This addendum (61 pages) shall form a part of and be included in the Contract Documents for the above titled project and no consideration will be entertained for extras to the Contract due to failure of the contractor to become thoroughly familiar with this addendum.

## ADDENDUM AD 03

<b>Project:</b>	Provincial Fire Life Safety – Lynn Lake, Gillam, and Thompson Sites	
<b>Commission Number:</b>	21569.44, 21569.49, 21569.50	SMS Project No.: 25-001-16
<b>Date:</b>	November 18, 2025	
<b>Pages:</b>	2 + 3 attachment/s

**1 MAIN FLOOR PLAN**  
**A1-211**  
 1:100M  
 north

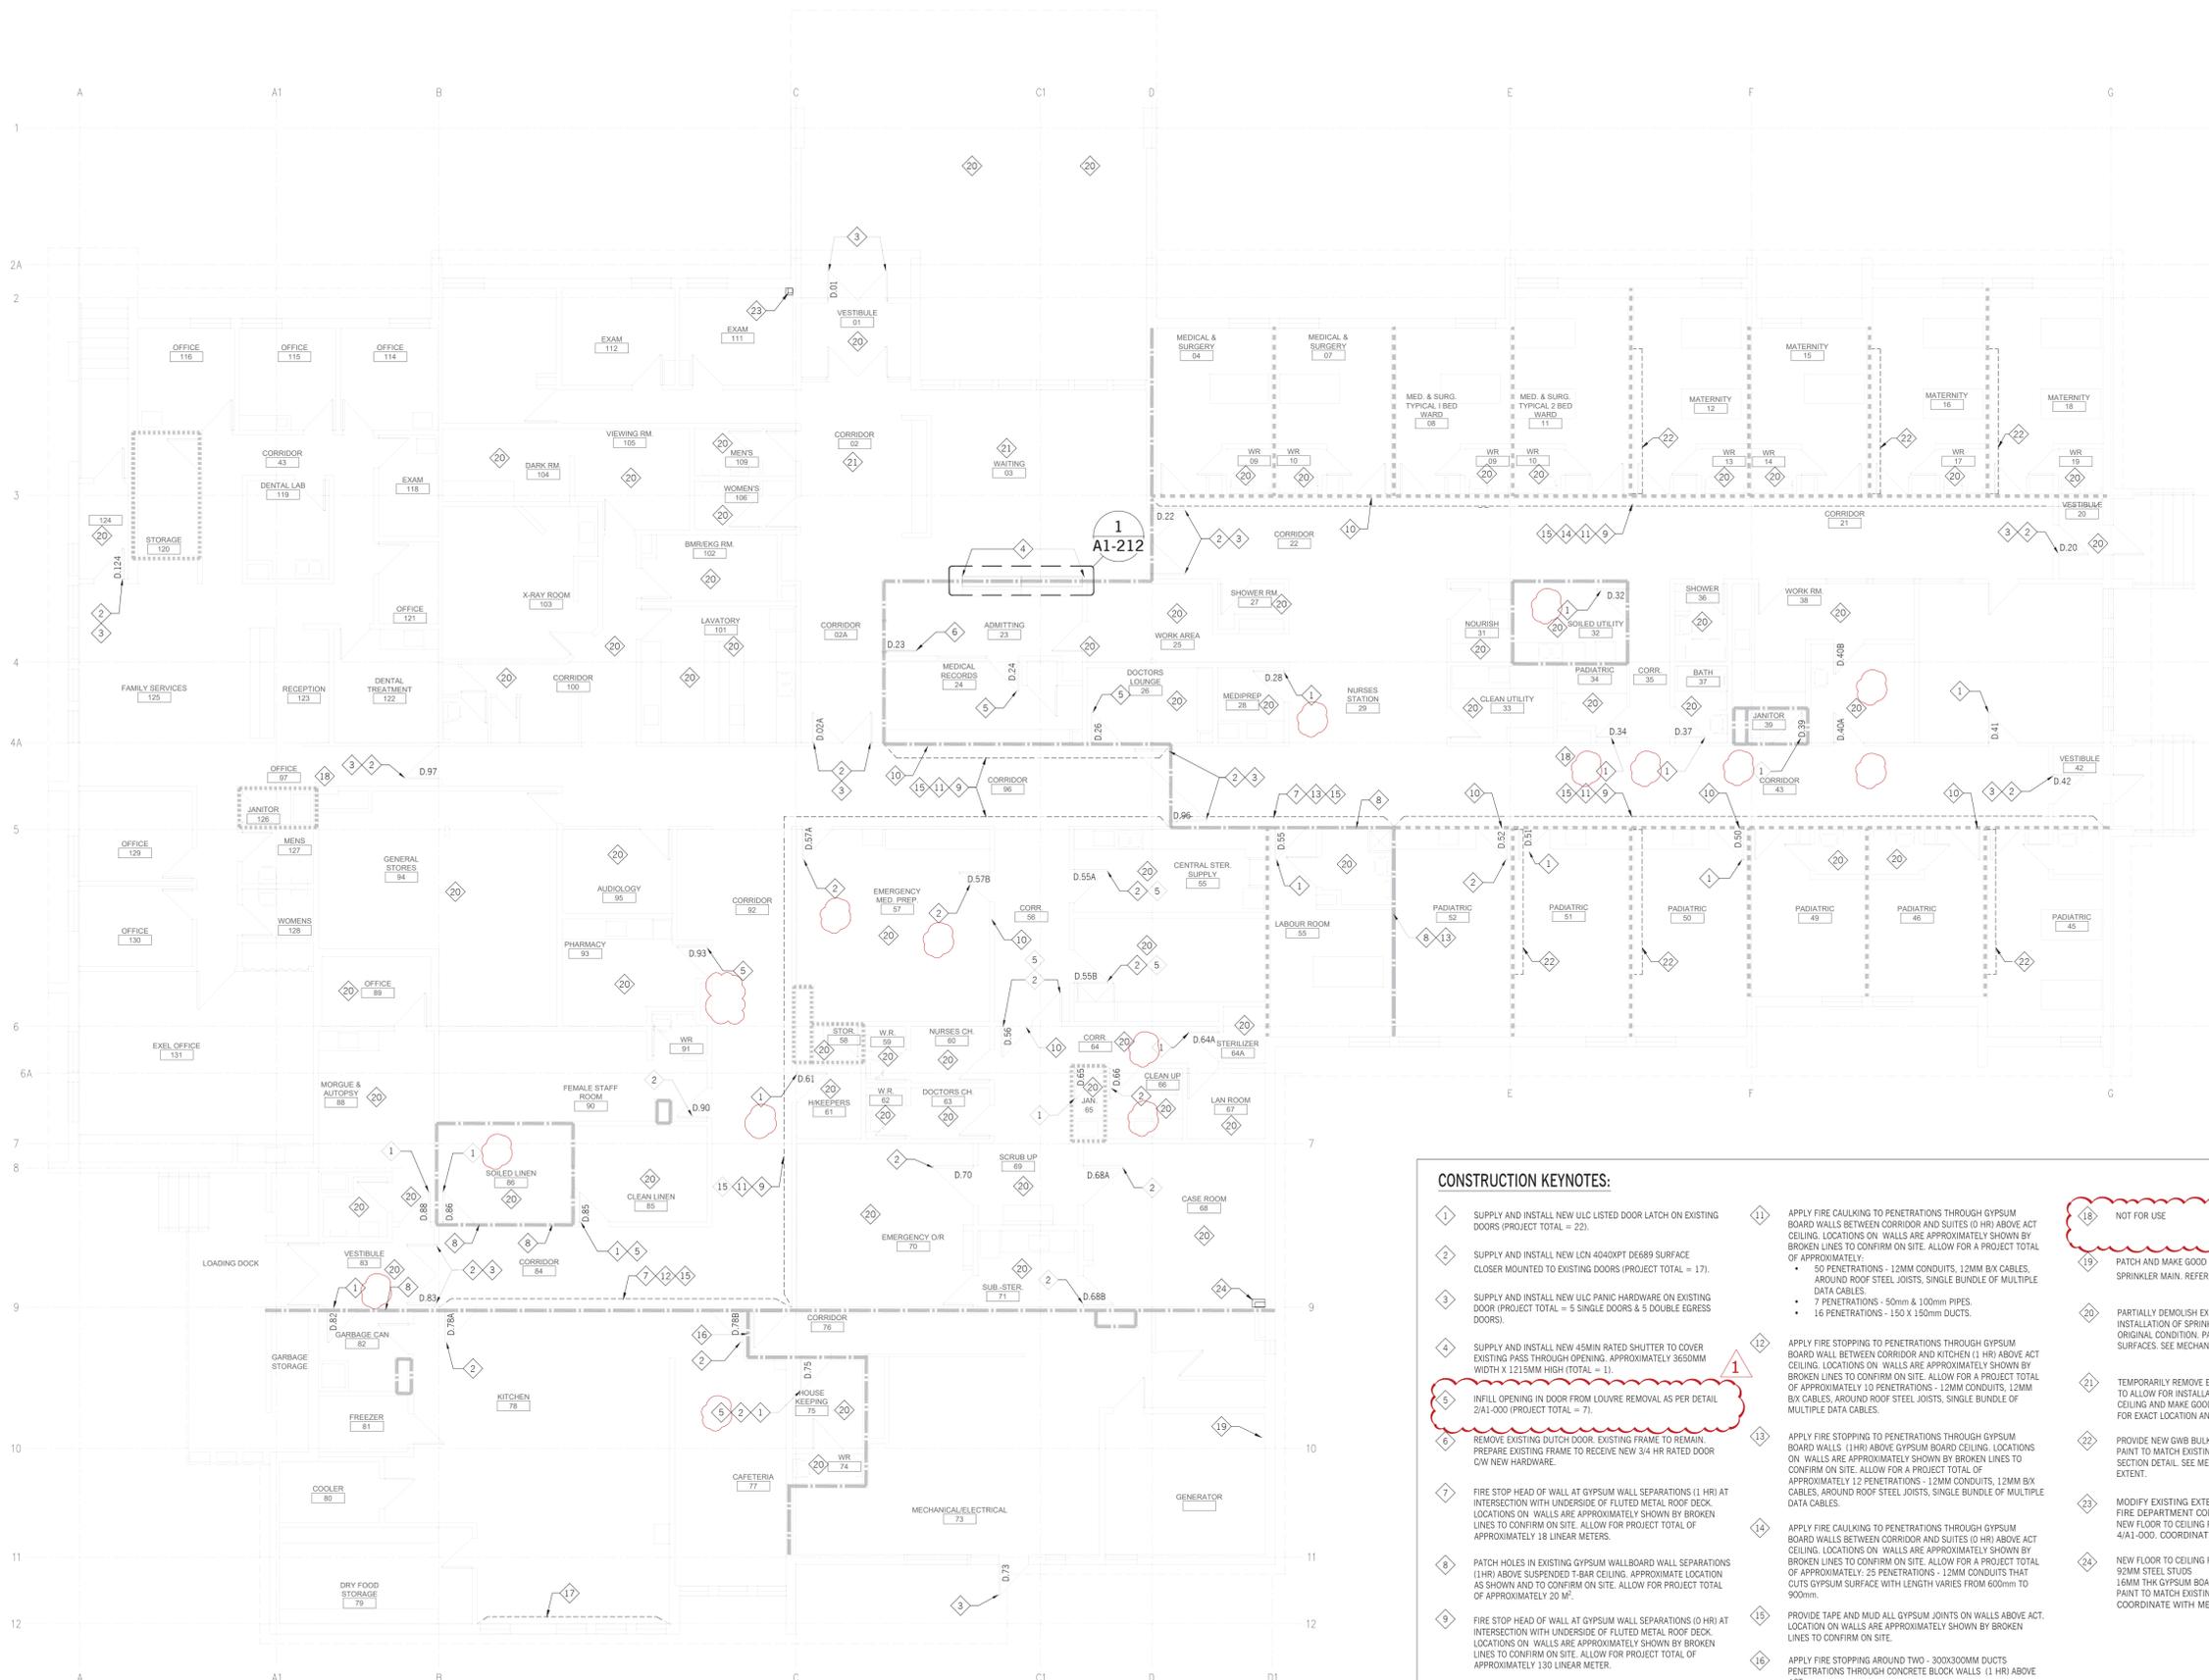
- 1.1 Replace Drawing A1-211 Construction main floor plan with attached revised Drawing A1-211  
Construction main floor plan – Addendum 03
- 1.2 Replace Drawing A4-113 Demolition Ground floor plan Block 3 with attached revised Drawing A4-113  
Demolition Ground floor plan Block 3 – Addendum 03
- 1.3 Replace Drawing A4-213 Construction Ground floor plan Block 3 with attached revised Drawing A4-113  
Construction Ground floor plan Block 3 – Addendum 03

Revision Number 0 Drawing Number S1-001

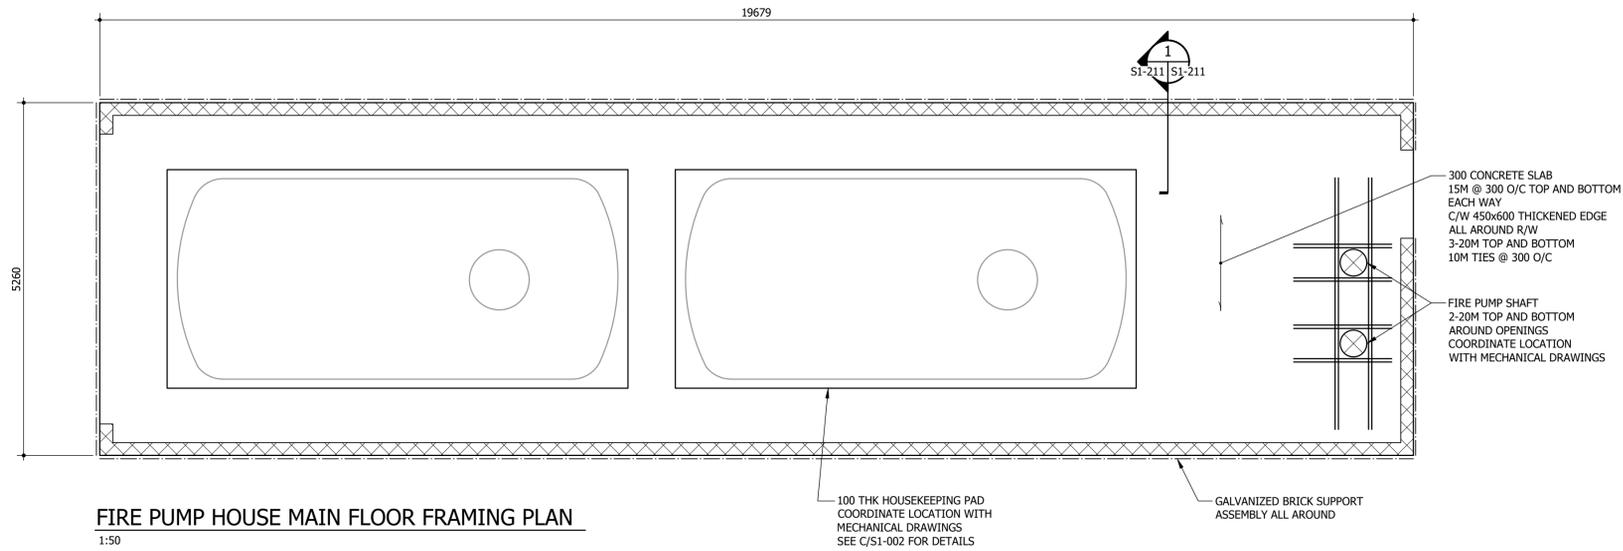
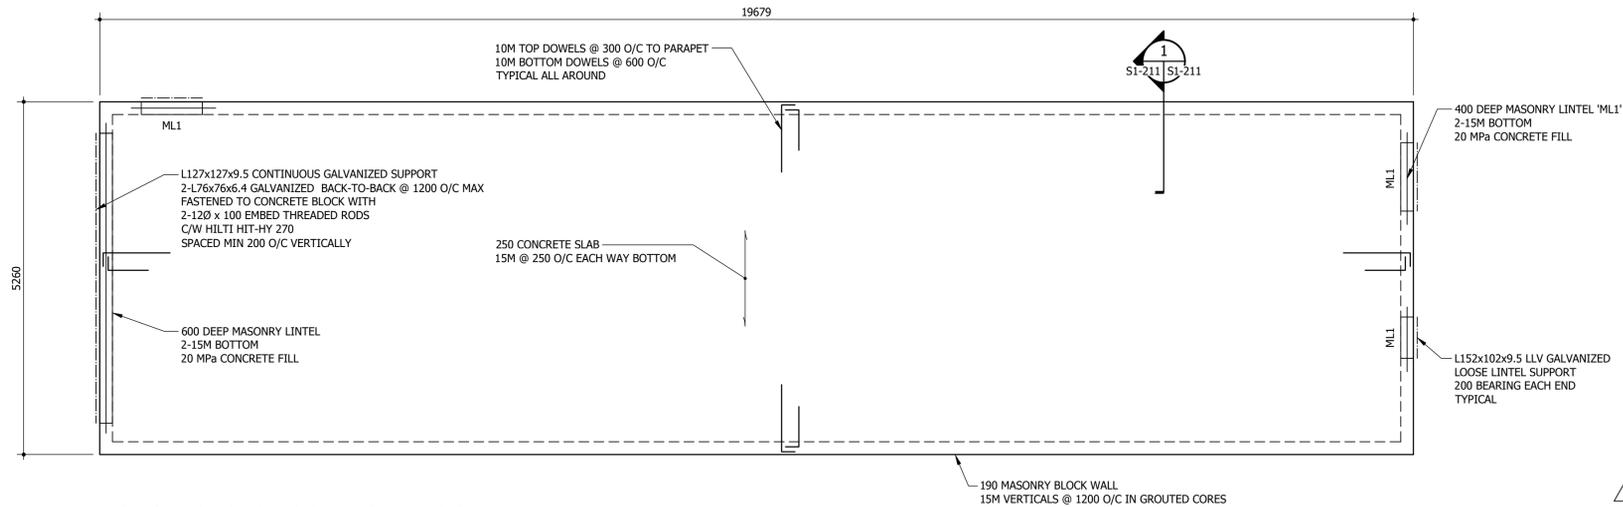
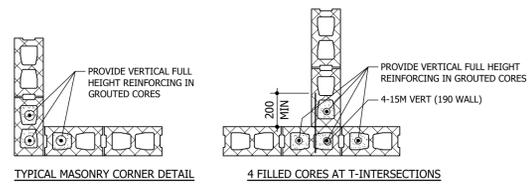
1. Refer to S1-001 (attached). In the general notes, updated site classification in earthquake loads section. Updated the foundation capacity and reference to the geotechnical report in the foundation section.
2. Refer to S1-211 (attached). In Section 1 and Section 2, modified the base requirements under the thickened edge slab based on the geotechnical report.

**1 BUILDING SECTION**  
 M1-223 SCALE: 1: 25

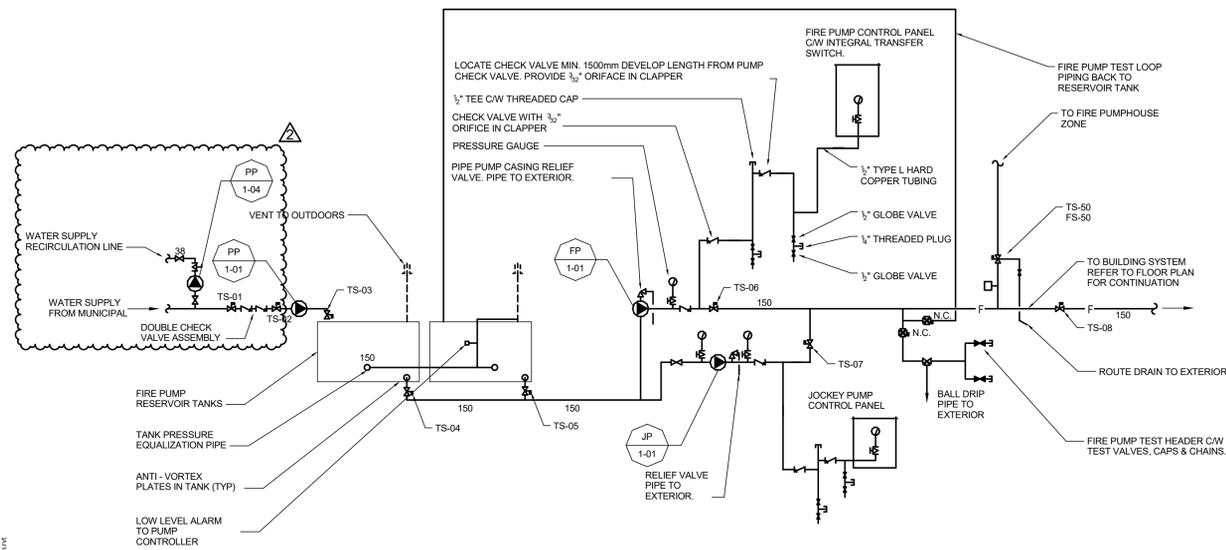
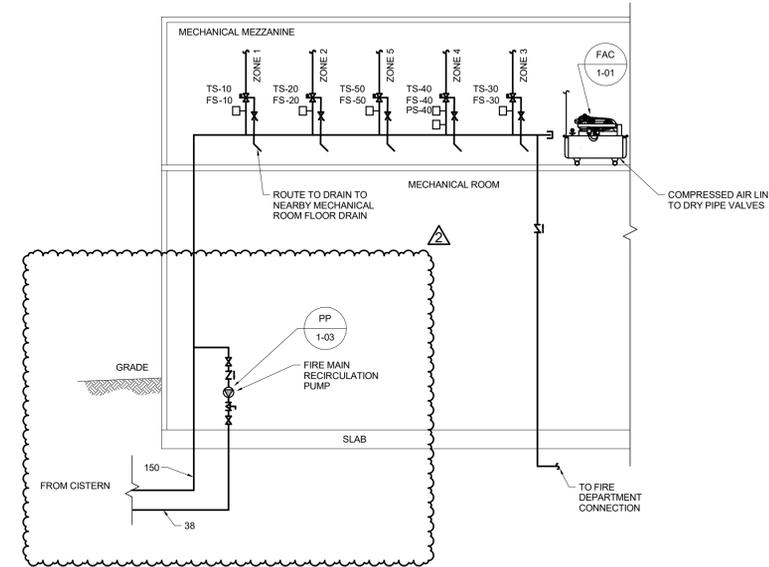
- .2 Domestic cold water supply recirculation line and associated pump PP 1-04 added.
- .4 Refer to attached drawing M1-223 Section & Schematics – Fire Protection – New Construction with clouded revisions.

- .1 Schematics clarified to include recirculation pumps.
  - .5 Refer to attached new drawing for Lynn Lake Hospital M1-321 Main Floor Plan - Mechanical - New Construction
